**Deep Geologic Repository Project for Low and Intermediate Level Waste –  
Submission of Responses to Information Requests**

Attachment to OPG letter, Albert Sweetnam to Dr. Stella Swanson, "Deep Geologic Repository Project for Low and Intermediate Level Waste – Submission of Responses to Information Requests"

## OPG Response to the Joint Review Panel EIS Information Requests Package 1

**Figure 2.7 (associated with IR-EIS-01-16). Ancestral Lakes of the Lake Huron Basin (Slattery 2011)**

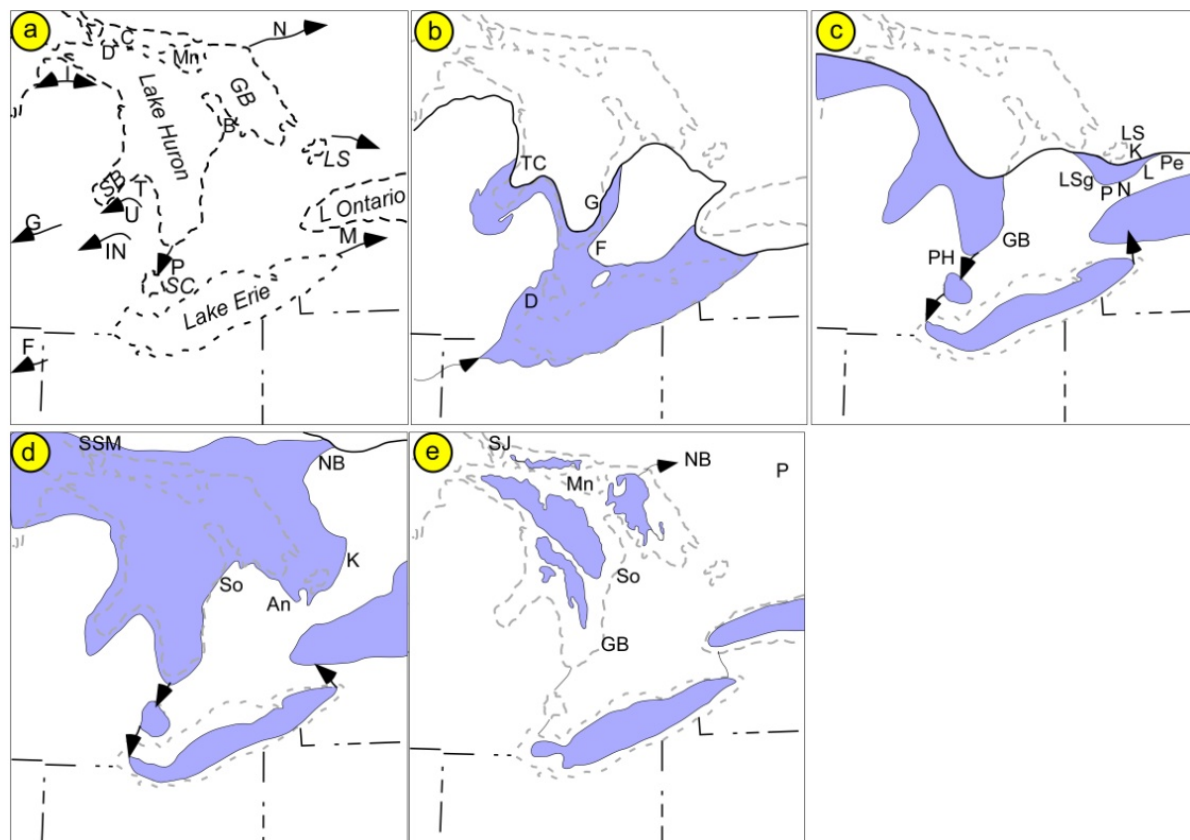
IR#	EIS Guidelines Section	Information Request and Response
EIS-01-16	<ul style="list-style-type: none"> <li>EIS Guidelines: Section 13.2, Selection of Assessment Scenarios</li> </ul>	<p><b>Information Request:</b></p> <p><i>Provide an assessment of how the Lake Huron coastal line would migrate in relation to the DGR site due to geomorphologic changes in the future (e.g. before the next glaciation arrives) and how the coastal line change would impact on the DGR, during the Normal Evolution Scenario.</i></p> <p><b>Context:</b></p> <p><i>In accordance with section 13.2 of the EIS Guidelines, "Long term assessment scenarios should be sufficiently comprehensive to account for all of the potential future states of the site and the environment."</i></p> <p><i>Geomorphologic studies (e.g., Lewis et al, 2008) have shown that the coastal line of Lake Huron has been going through constant geomorphologic changes in the past 10,000 or so years. It is essential to have an understanding on how the trend will continue, even before the next glaciation arrives. The effect of the change on the DGR project needs to be considered in the Normal Evolution Scenario, given that this scenario represents the most likely long-term outlook.</i></p> <p><b>OPG Response:</b></p> <p>The response is provided in two parts, a discussion of shoreline evolution processes and a discussion of impacts on the DGR safety assessment results.</p> <p><u>1. Shoreline evolution</u></p> <p>Presently the DGR surface facilities are approximately 1 km inland and 10 m above the Lake Huron shoreline. There are a number of factors that will influence the evolution of the shoreline.</p> <ul style="list-style-type: none"> <li>Erosion - Erosion of shoreline is not expected to be significant in the near term (hundreds of years) since the Lake Huron shoreline fronting the Bruce nuclear site consists of either beaches armoured with cobbles and boulders or exposed bedrock (AMEC 2011, Section 3.3.7).</li> <li>Global warming - The effect of global climate change on the lake level is not certain. Based on several recent projections, the range in lake level is 0.5 m rise to a 1.5 m fall in the next 50-100 years (AMEC 2011, p.46). These would cause the shoreline to move slightly farther away or slightly closer towards the DGR site.</li> <li>Glacial rebound - The weight of the ice during the previous glaciation caused continental-scale crustal depression (Peltier 2011, Section 4.2.5). After the ice sheet melted, the crust has been slowly rebounding, with the rate decreasing with time. In the Great Lakes region, the rebound rate is about 1.5 mm/yr (NWMO 2011, Section 2.2.7.1). The rate is slightly higher to the north, so that the northern part of Lake Huron (e.g., Georgian Bay) is rising slightly faster than southern Lake Huron (e.g., Lake St. Clair area). This could move the shoreline away from the site over thousands of years.</li> </ul>

IR#	EIS Guidelines Section	Information Request and Response
		<ul style="list-style-type: none"> <li>Climate change (glacial cycles) - The historical record indicates that there have been large fluctuations (approximately +/- 50 m) in the Great Lakes' water levels in the last 10,000 years as the ice sheet retreated, due to natural climate changes (including an early Holocene dry climate), the extent of ice sheet coverage, and glacial depression of the land (Lewis et al. 2008, Slattery 2011). As illustrated in Figure 2.7 from Slattery (2011) (provided at the end of the responses to EIS IRs), these changes have led to a range of lake shorelines, from several kilometres distance from the site, to the site being fully covered. If glaciation resumes in the longer term (tens of thousands of years), the lake shoreline would initially move away from the DGR site as the climate became cooler and drier. Eventually it would be covered by an ice sheet, land or water as the ice sheet advanced or retreated across the site. Peltier (2011, Section 4.2.4) provides estimates of lake depth at the repository site over the course of a glacial cycle.</li> </ul> <p><u>2. Influence of lake shoreline changes on DGR safety assessment</u></p> <p>The postclosure impacts for the Normal Evolution and Disruptive Scenarios are primarily based on an assumed self-sufficient farming family living on top of the repository site, and extracting water from a well located downstream from the repository. This family obtains fish from the near-shore region of the lake. In the model, the shallow groundwater system (Bass Island Formation and above) discharges into the near-shore of the lake after a transit of about 1 km, the current horizontal distance to the shoreline. This is less than the likely distance at which these formations intercept the lake bottom, but this maximizes potential dose as there is less dilution in the near-shore region.</p> <p>If the shoreline were further away, the well-based receptor exposure model would still apply. The reference 1-km transport assumption for shallow groundwater-to-lake would become more conservative. There would be little effect on calculated doses as the lake water exposure is a minor pathway compared with the well water pathway.</p> <p>If the shoreline were much closer to the site, the family would be more likely to extract water from the lake rather than the well. Contaminants would be dispersed within the lake and would have overall more dilution relative to the reference farmer model using a well. This would result in a lower dose than presently calculated.</p> <p>If the repository site was fully covered by the lake, there would be no possibility of living on top of the repository. Contaminants would also be dispersed within the lake and would have overall more dilution relative to the reference self-sufficient farmer model. In this circumstance the dose consequence would be lower than calculated for the reference case.</p> <p>The assessment also considers a future periglacial (cold) climate state associated with glacial cycles. In this case, the shoreline is assumed to be some distance from the site, with groundwater discharge into a nearby stream. The receptor in this case still uses a well for domestic water and some garden crops, but uses less irrigation water as the climate is not suitable for general agriculture. Fish are obtained from the local stream, as well as the lake. This alternative climate state results in about 3-4 time higher dose than those calculated</p>

IR#	EIS Guidelines Section	Information Request and Response
		<p>from the reference case temperate biosphere, but it remains many orders of magnitude smaller than the dose criterion (Quintessa et al. 2011, Section 7.3.2.11).</p> <p>Therefore, the receptor model for assessing impacts is appropriate and sufficiently conservative to account for changes in the lake shoreline relative to the DGR site.</p> <p><b>References:</b></p> <p>AMEC NSS. 2011. Maximum Flood Hazard Assessment. AMEC NSS Ltd. report for the Nuclear Waste Management Organization NWMO DGR-TR-2011-35 R000. Toronto, Canada.</p> <p>Lewis, C.F.M, P. Karrow, S. Blasco, F. McCarthy, J. King, T. Moore and D. Rea. 2008. Evolution of lakes in the Huron basin: deglaciation to present. J. Aquatic Ecosystem Health &amp; Management <u>11</u>(2), 127-136.</p> <p>NWMO. 2011. Geosynthesis. Nuclear Waste Management Organization report NWMO DGR-TR-2011-11 R000. Toronto, Canada.</p> <p>Peltier, W. 2011. Long-Term Climate Change. Nuclear Waste Management Organization report NWMO DGR-TR-2011-14 R000. Toronto, Canada. (available at <a href="http://www.nwmo.ca/dgrgeoscientificsitecharacterization">www.nwmo.ca/dgrgeoscientificsitecharacterization</a>)</p> <p>Quintessa, Geofirma and SENES. 2011. Postclosure Safety Assessment. Quintessa Ltd., Geofirma Engineering Ltd. and SENES Consultants Ltd. report for the Nuclear Waste Management Organization NWMO DGR-TR-2011-25 R000. Toronto, Canada.</p> <p>Slaterry, S. 2011. Neotectonics Features and Landforms Assessment. Nuclear Waste Management Organization report NWMO DGR-TR-2011-19 R000. Toronto, Canada. (available at <a href="http://www.nwmo.ca/dgrgeoscientificsitecharacterization">www.nwmo.ca/dgrgeoscientificsitecharacterization</a>)</p>

**Figure 1 (associated with IR-EIS-01-24).** Petroleum occurrences, mapped faults and prominent tectonic features of southern Ontario. Also shows the sample locations from Obermajer et al. (1999) and the interpreted block boundaries of Sanford et al. (1985).

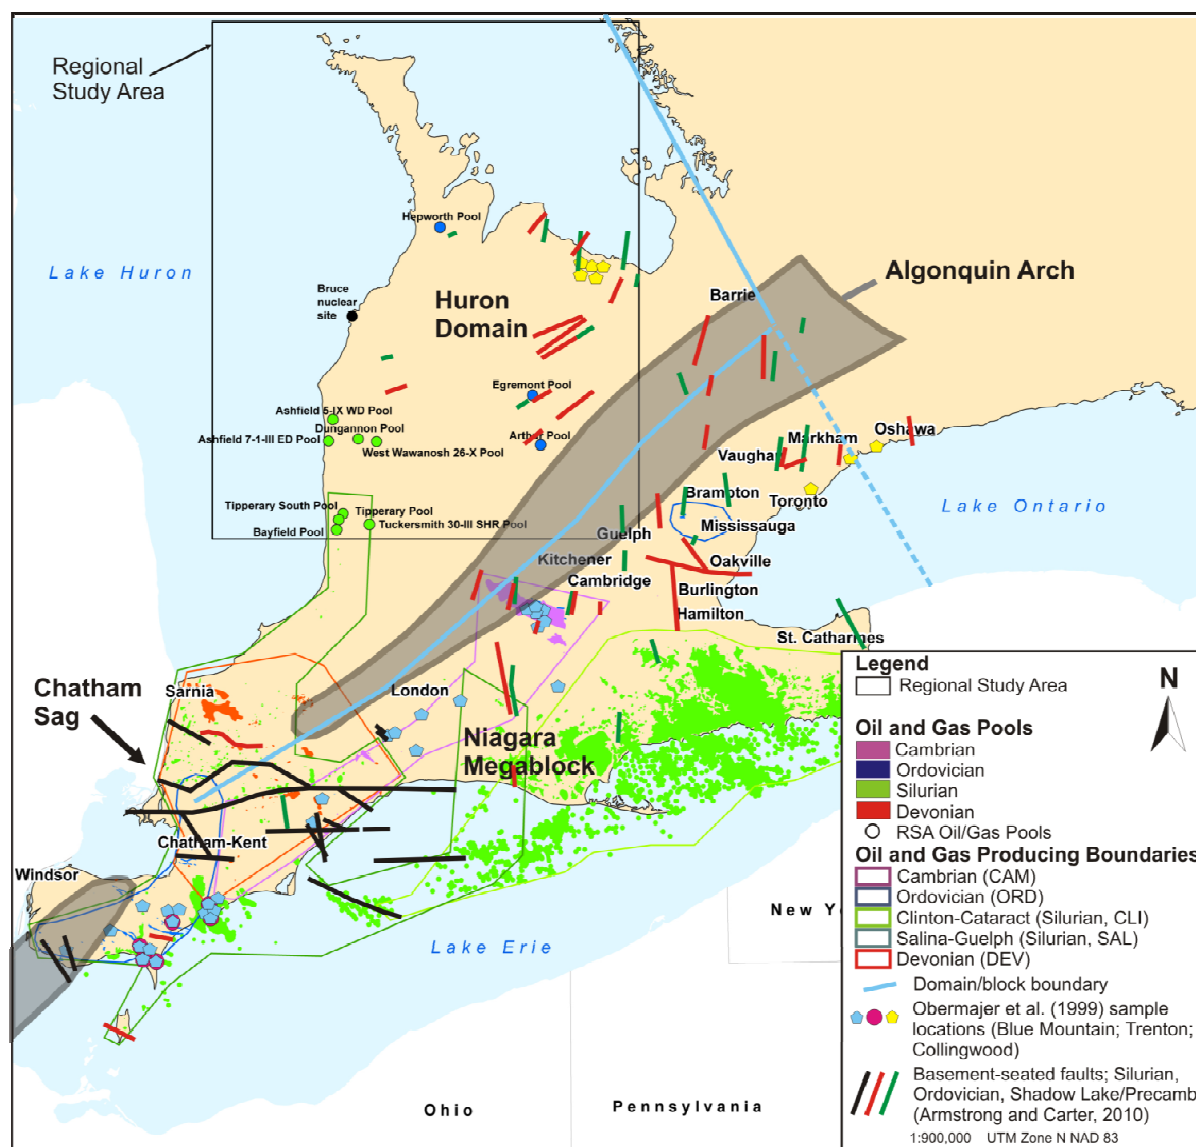
EIS-01-24	<ul style="list-style-type: none"> <li>▪ EIS Guidelines: Sections 12, 13.2 and 15</li> <li>▪ CNSC Regulatory Guide G-320: Section 7.5.2</li> </ul>	<p><b>Information Request:</b></p> <p><i>Provide an assessment of undiscovered oil, gas and mineral resources at the regional, local and site scale and also the uncertainties that are associated with this assessment.</i></p> <p><i>In providing the above assessment, the proponent should clearly distinguish between resources and reserves. Reserves are generally understood to comprise those accumulations that have been discovered and measured, and that can be produced economically under present-day conditions. Reserves are only a sub-set of total resources, which also include potential future additions to reserves that are currently sub-commercial and/or that have yet to be discovered and measured.</i></p> <p><i>The requested quantitative assessment should also be correlated to the geological processes responsible for the formation of the resources.</i></p>

IR#	EIS Guidelines Section	Information Request and Response
		<p>consistent with reservoir quality rocks.</p> <ul style="list-style-type: none"> <li>• The ability to extrapolate these site-specific observations beyond the DGR borehole footprint is based on the predictable and traceable nature of the Paleozoic stratigraphy across the Regional Study Area as discussed in the Geosynthesis (NWMO 2011; Section 2.3.4; Intera 2011; Section 3.1.3). The nearest neighbour exploratory wells to the Bruce site (Texaco #6 and Kincardine #1) were dry and this is consistent with the fact that no documented commercially viable oil or natural gas hydrocarbon deposits (27 exploratory wells) are found within a 40 km radius of the Bruce nuclear site (OGSR 2004; 2006; AECOM and Itasca 2011).</li> <li>• The probability of the occurrence of commercial shale gas beneath the Bruce nuclear site is considered low for three reasons: i) the Total Organic Carbon (TOC) concentration within the Ordovician strata is low ca. &lt; 2.5%; ii) the low thermal maturity due to shallow (approximately 1.5 km) burial in the Bruce region; and iii) lack of extensive natural hydraulic fracturing in the Ordovician shales associated with gas generation typical of shale gas plays in the Appalachian basin (Engelder 2011).</li> <li>• The Paleozoic sediments within southern Ontario are subdivided into two structural domains; the Niagara megablock and the Huron Domain (see Figure 1 provided at the end of the responses to EIS IRs). The Huron Domain, which encompasses the DGR Regional Study Area (Figure 1 herein), is structurally less complex than the faulted Niagara megablock (Figure 1 provided at the end of the responses to EIS IRs; AECOM and Itasca 2011, p. 116). The structural provenance of the Huron Domain suggests a lower possibility of HTD formation and occurrence for oil and gas accumulation. Further, Bailey (2005) noted that the best prospecting for Ordovician HTD reservoirs should occur on the south east side of the Algonquin Arch where the presence of porous Cambrian sediments have facilitated the transport and migration of fluids within the fault and fracture systems. Active and abandoned gas pools within the Regional Study Area are listed in NWMO (2011), Table 8.2.</li> <li>• Present industry exploration for Ordovician HTD reservoirs is focused almost exclusively in Essex and Kent counties in the Niagara Megablock (AECOM and ITASCA CANADA 2011, p. 126). Hydrocarbon resources to the northeast of this area, in the Huron Domain, particularly within the Black River Group tend to be largely related to gas discoveries (NWMO 2011; Table 8.2).</li> <li>• In terms of mineral resources, no evidence was discovered during regional or site specific investigations to suggest economically viable base mineral or salt deposits exist beneath or in the vicinity of the Bruce nuclear site (e.g., Silurian Saline salt). The observation that base minerals occur as trace gangue mineral assemblages indicates that the likelihood of undiscovered base mineral resources is considered negligible (NWMO 2011; Sections 2.2.8 and 2.3.6).</li> </ul>

IR#	EIS Guidelines Section	Information Request and Response
		<p>With respect to Obermajer et al. (1999), as cited above, broad application of conclusions to understanding petroleum resource potential within the vicinity of the Bruce nuclear site and more regionally within the Huron Domain, to the northwest of the Algonquin Arch is not straightforward. Obermajer et al. (1999) principally explored hydrocarbon occurrence in the middle Ordovician limestone to the southeast of the Algonquin Arch in the Niagara Mega Block, in sediments associated with the Appalachian basin (Figure 1 provided at the end of the responses to EIS IRs; sample locations). Differences in hydrocarbon rock thermal maturity, structural provenance (as described above) and occurrence of underlying Cambrian sediments indicate that direct transferability of observations from Obermajer et al. (1999) to the Huron Domain is not well supported.</p> <p><b>References:</b></p> <p>AECOM and ITASCA CANADA. 2011. Regional Geology – Southern Ontario. AECOM Canada Ltd. and Itasca Consulting Canada, Inc. report for the Nuclear Waste Management Organization NWMO DGR-TR-2011-15 R000. Toronto, Canada. (available at <a href="http://www.nwmo.ca/dgrgeoscientificsitecharacterization">www.nwmo.ca/dgrgeoscientificsitecharacterization</a>)</p> <p>Bailey, S.M.B. 2005. A Comparison of Cambrian Reservoir Rocks Onlapping the S.E. and N.W. Sides of the Algonquin Arch in SW Ontario: A Regional Correlation Project. Proceedings 44th Annual Ontario Petroleum Institute Conference, Technical Paper 5. London, Canada.</p> <p>Engelder, T. 2011. Analogue Study of Shale Cap Rock Barrier Integrity. Nuclear Waste Management Organization Report NWMO DGR-TR-2011-23 R000. Toronto, Canada. (available at <a href="http://www.nwmo.ca/dgrgeoscientificsitecharacterization">www.nwmo.ca/dgrgeoscientificsitecharacterization</a>)</p> <p>Intera Engineering Ltd. 2011. Descriptive Geosphere Site Model. Intera Engineering Ltd. report for the Nuclear Waste Management Organization NWMO DGR-TR-2011-24 R000. Toronto, Canada.</p> <p>NWMO. 2011. Geosynthesis. Nuclear Waste Management Organization report NWMO DGR-TR-2011-11 R000. Toronto, Canada.</p> <p>Obermajer, M., M.G. Fowler and L.R. Snowdon. 1999. Depositional environment and oil generation in Ordovician source rocks from southwestern Ontario, Canada: Organic geochemical and petrological approach. AAPG Bulletin 83 (9), 1426-1453.</p> <p>Ontario Oil, Gas and Salt Resources (OGSR) Library. 2004. Cumulative oil and gas production in Ontario to the end of 2004. Excel format data. In: Members Package Dataset. Petroleum Resources Centre, Ministry of Natural Resources Oil, Gas &amp; Salt Resources Library.</p> <p>Ontario Oil, Gas and Salt Resources (OGSR) Library. 2006. Oil and Gas Pools and Pipelines of Southern Ontario, revised October 2006. Petroleum Resources Centre, Ministry of Natural Resources Oil, Gas &amp; Salt Resources Library UTM NAD83. Ontario Digital Base Data.</p>
